**ACTION TRANSMITTAL No. 2014-22**

**SUBJECT:** Scope Change Request for the Crystal Lake Regional Trail in Robbinsdale  
**REQUESTED ACTION:** Three Rivers Park District requests a scope change to modify the scope of SP#091-090-075 to increase the length by 0.4 miles, change the trail alignment, eliminate three bridges, change approximately 0.5 miles of the project from off-road trail to on-street facility with shared lane markings, and move the regional trail head facilities. The change would reduce the budget to a total of \$2,600,000 with \$1,840,000 in Surface Transportation Program (STP) funds (less than the \$2,163,200 originally programmed) and an increased local amount of \$760,000.

**Subject:** Crystal Lake Regional Trail (Robbinsdale Segment)  
Additional Information for Amendment Request  
SP# 091-090-075

SHEET 48 OF 713

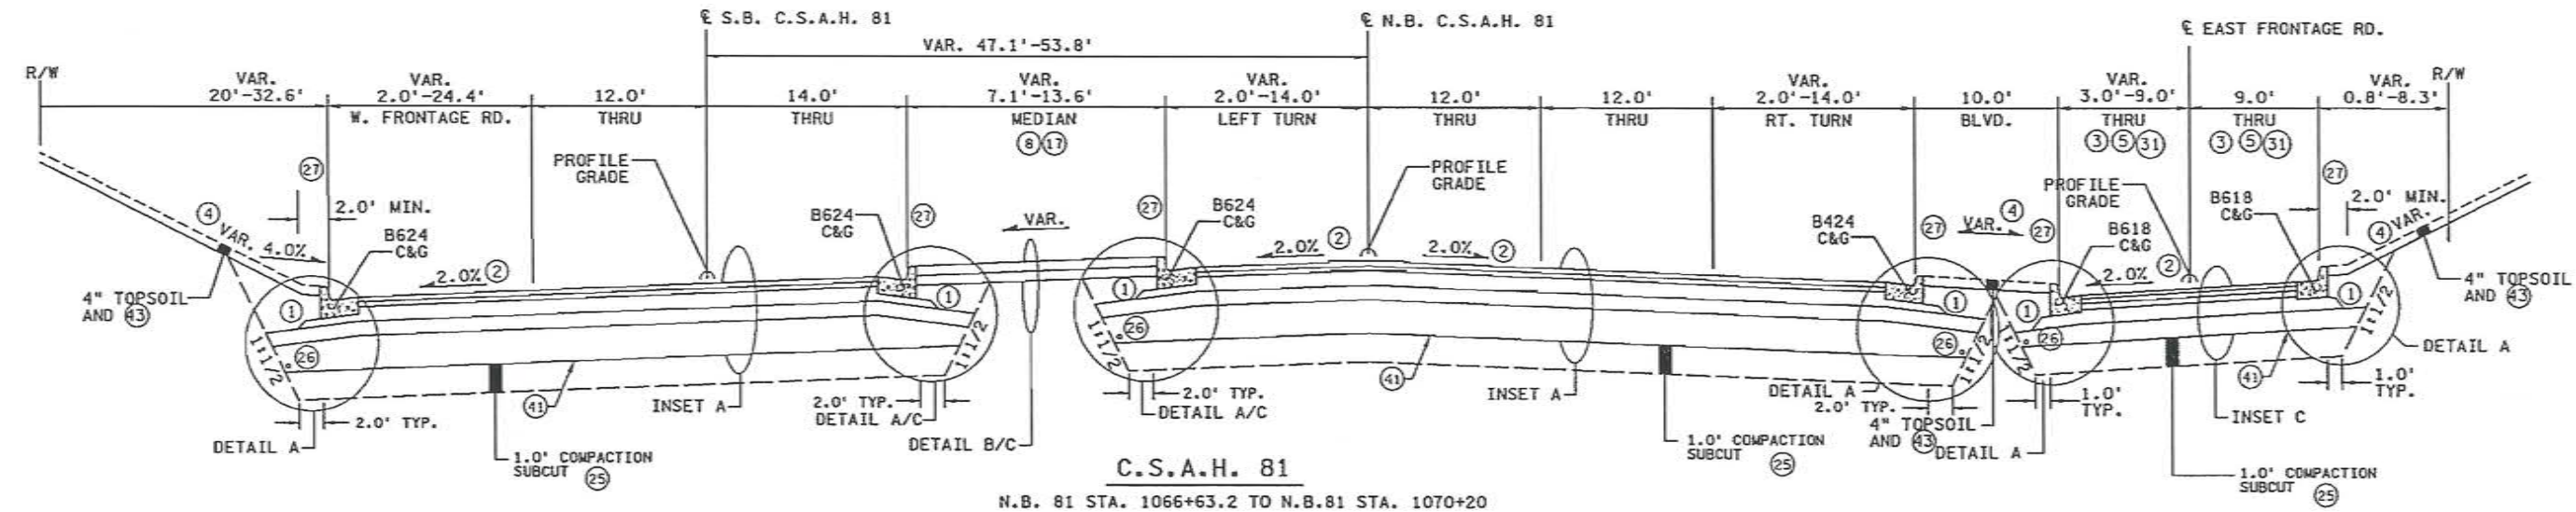
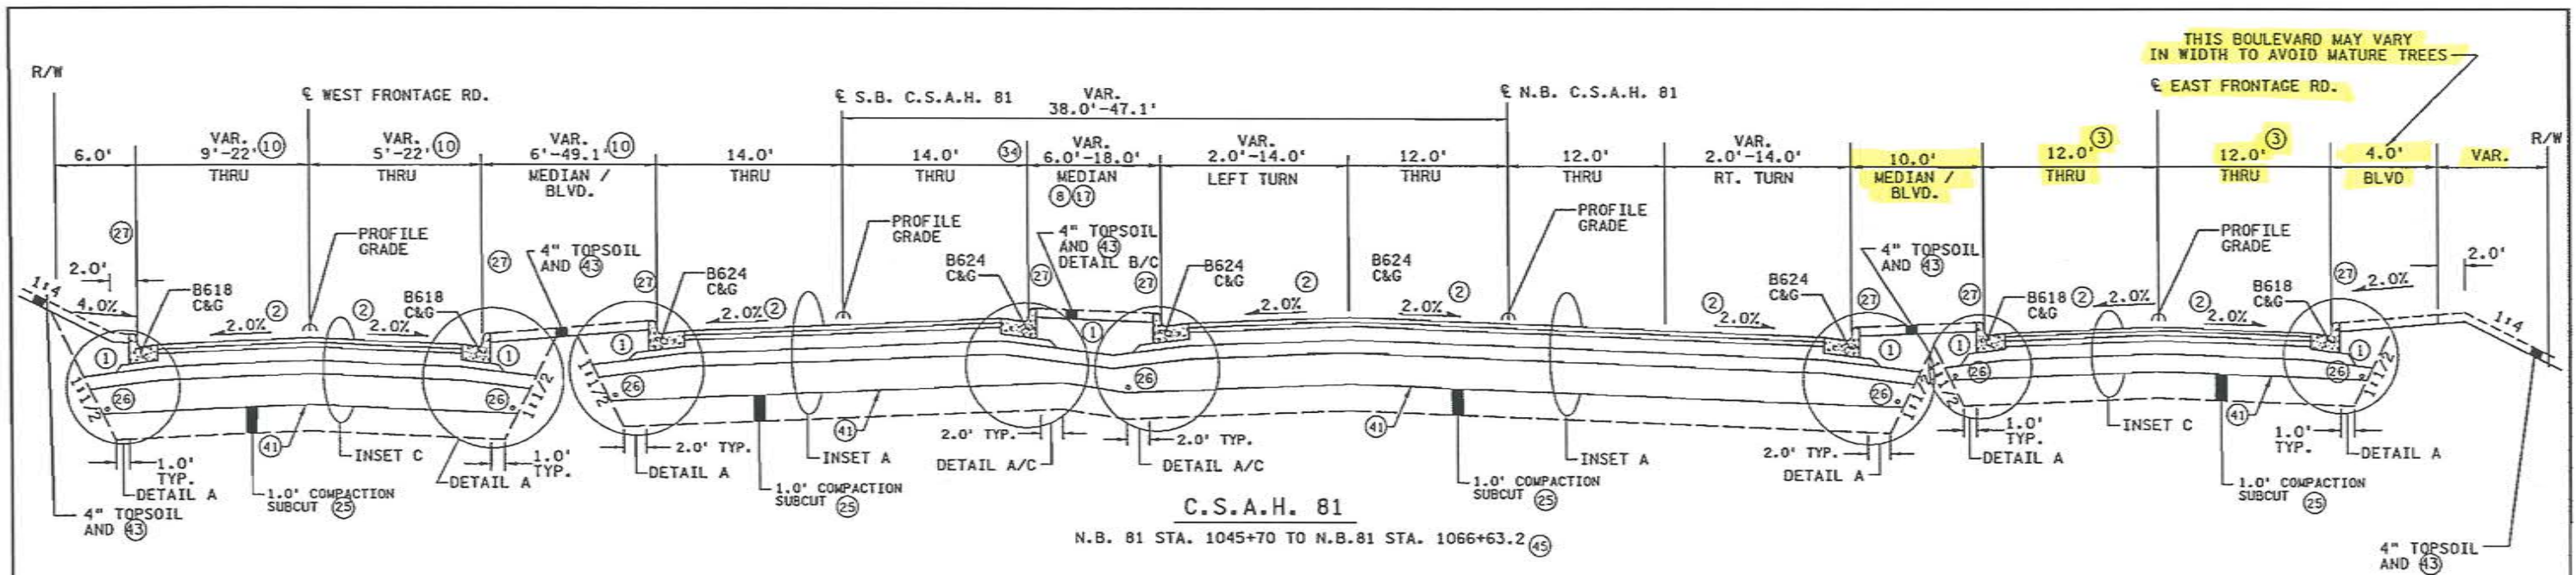
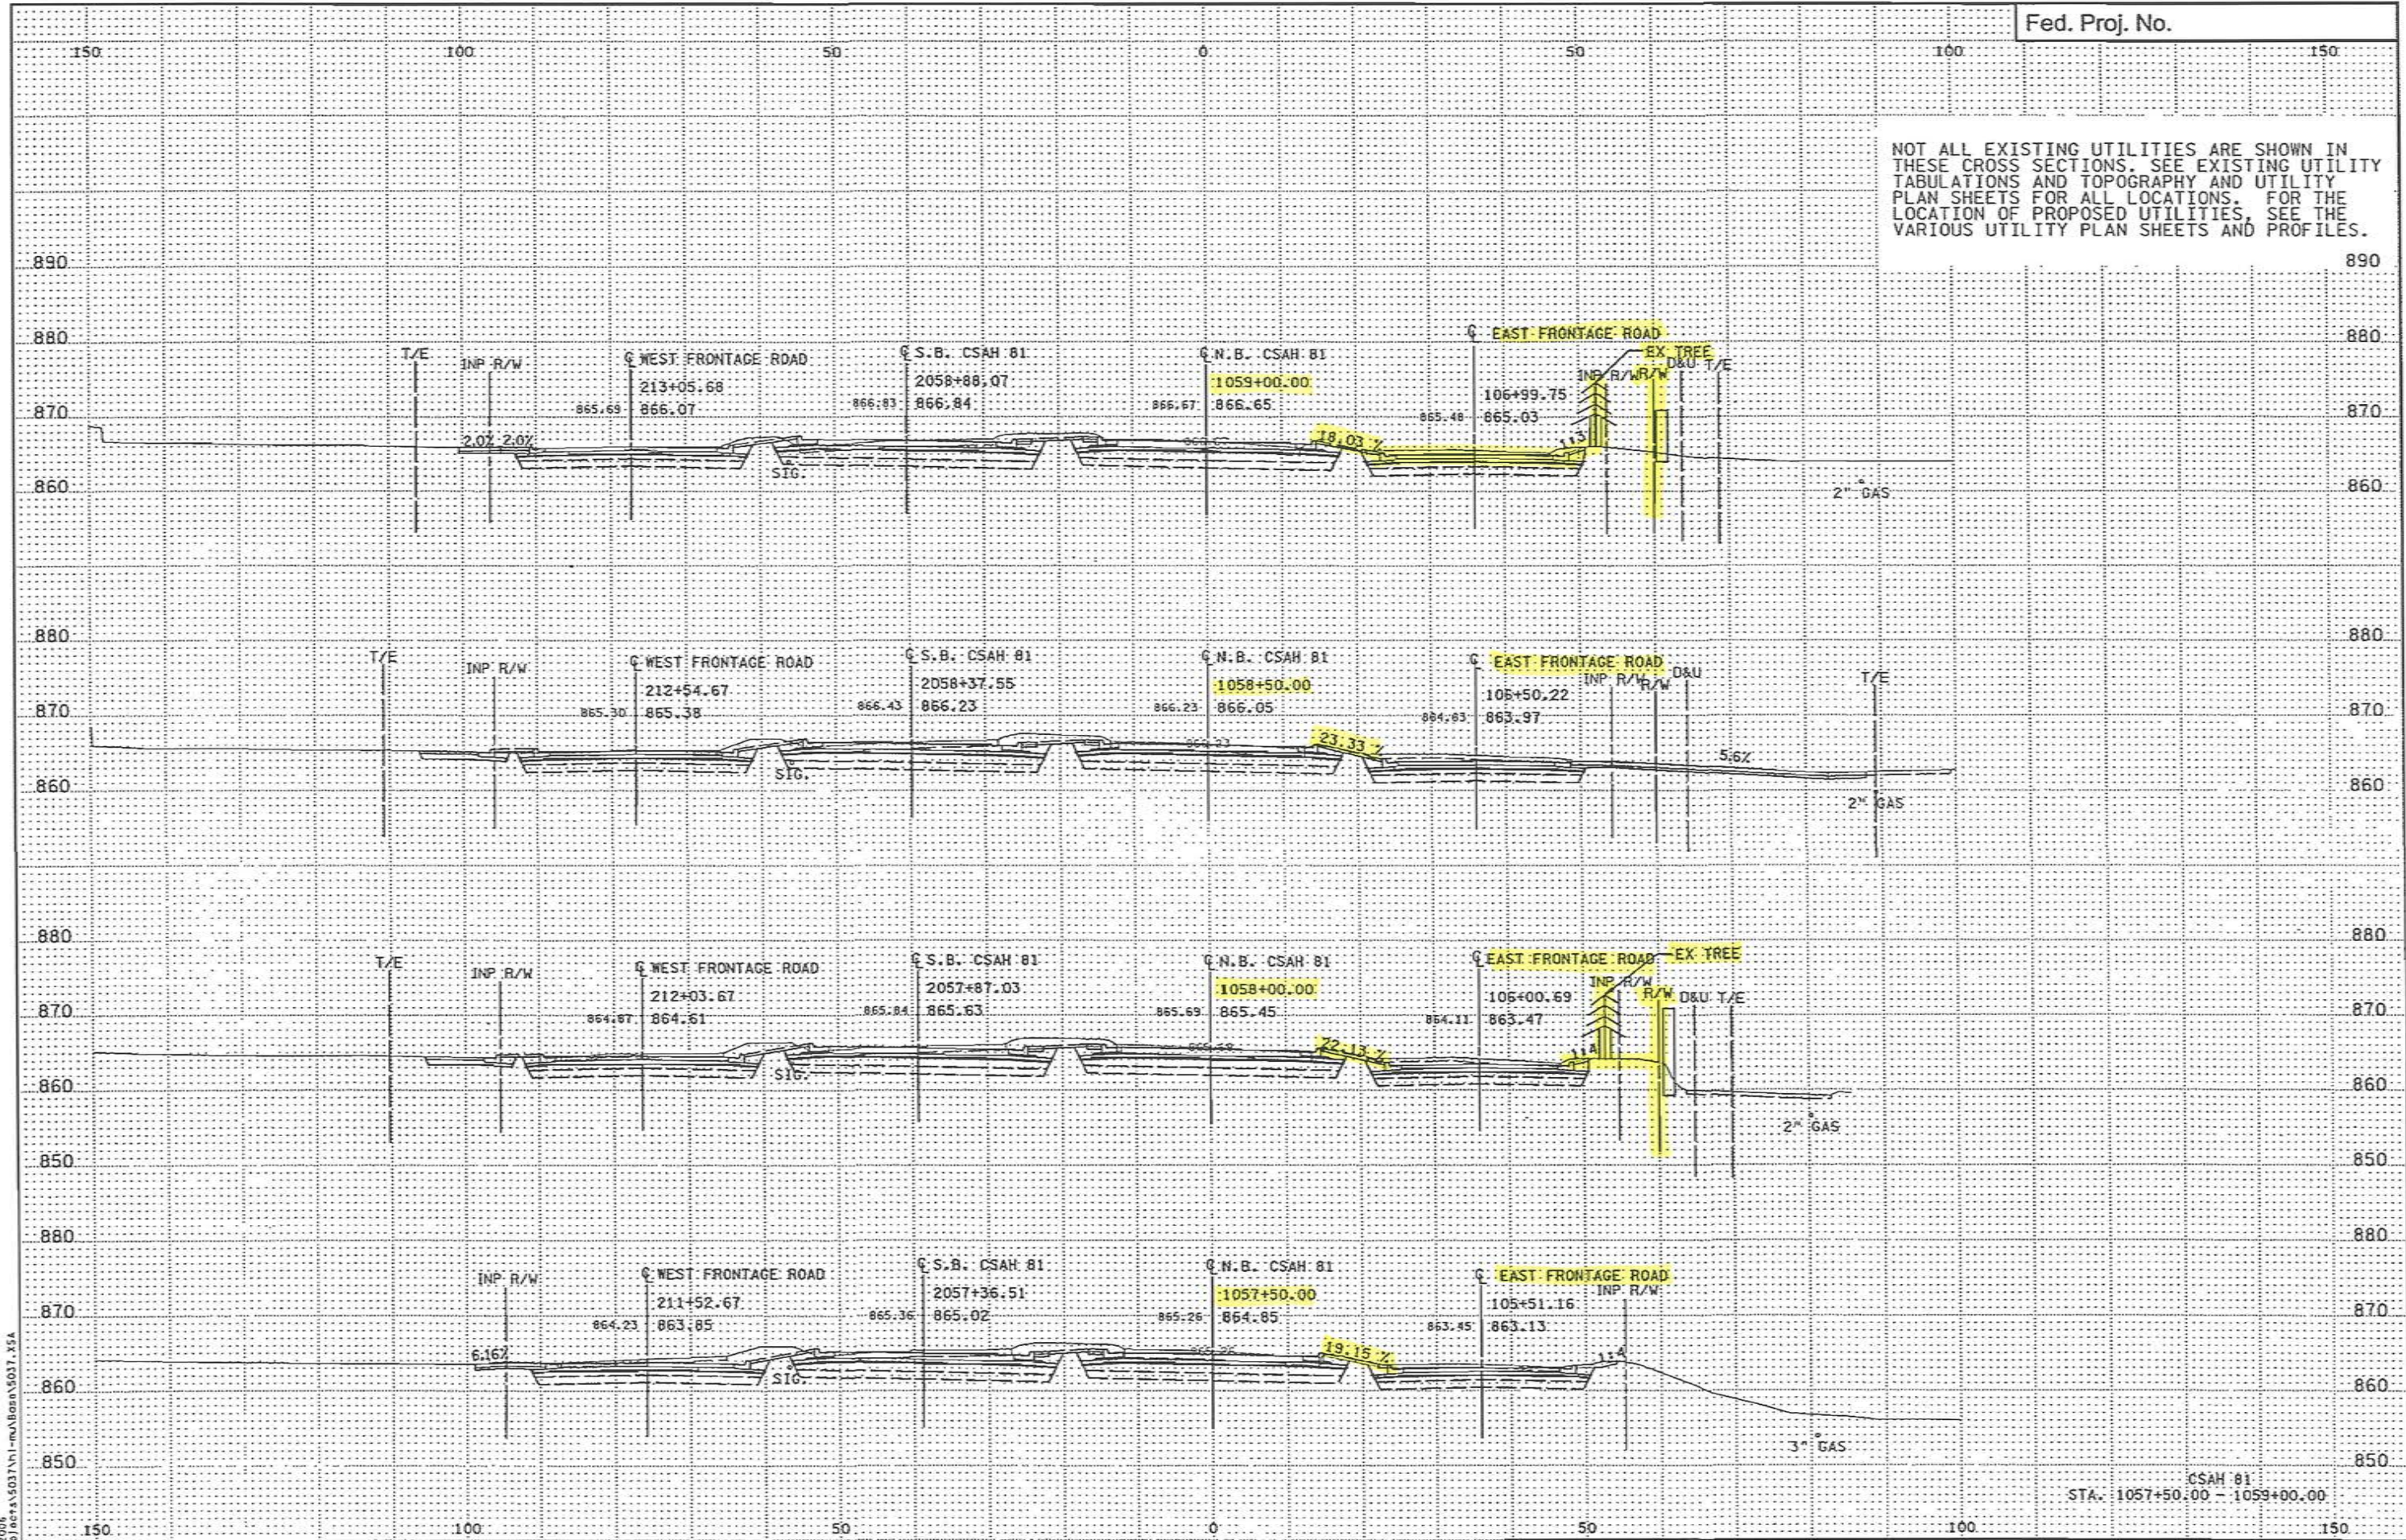
- Typical Sections from the CSAH 81 Reconstruction Project (Sheet 48 of 713) – Note the width of the frontage road and narrow boulevard between CSAH 81 and the East Frontage Road

CSAH 81  
STA. 1057+50.00 - 1059+00.00

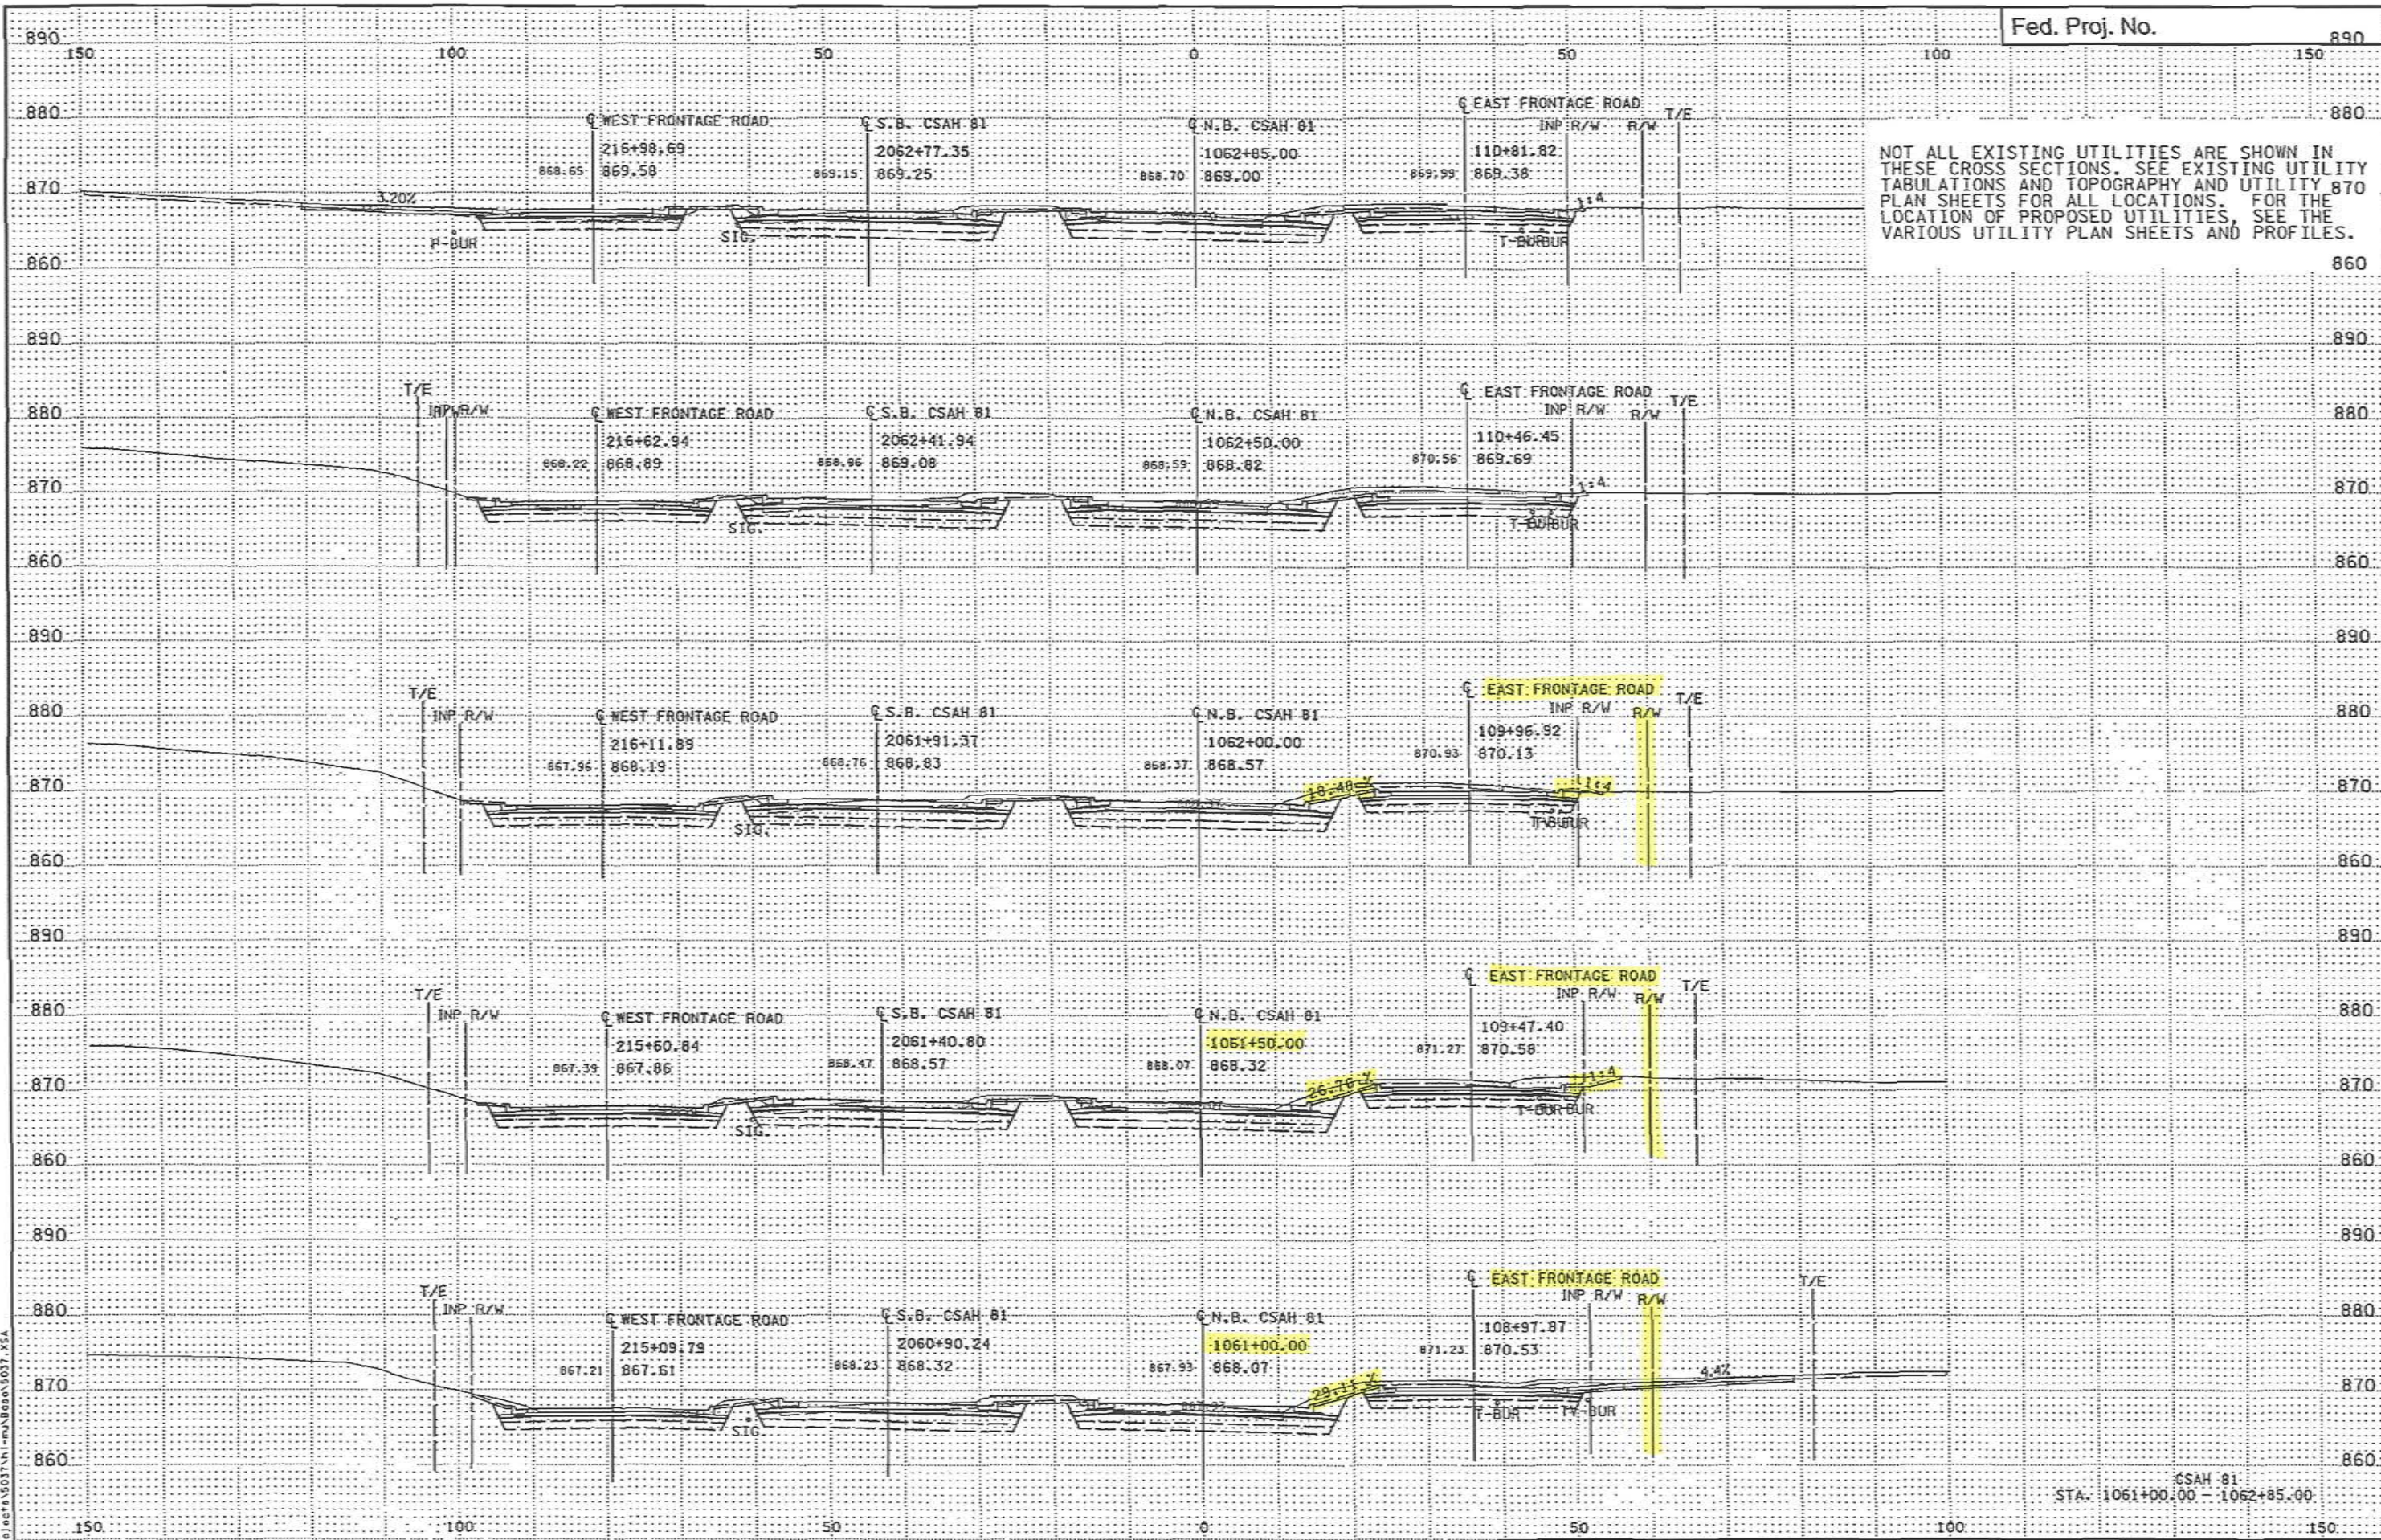
- Cross Sections from the CSAH 81 Reconstruction Project (Sheets 660-662 of 713) – Note the significant walls, trees and slopes in the boulevard of the East Frontage Road as well as the steep slope between CSAH 81 and the East Frontage Road
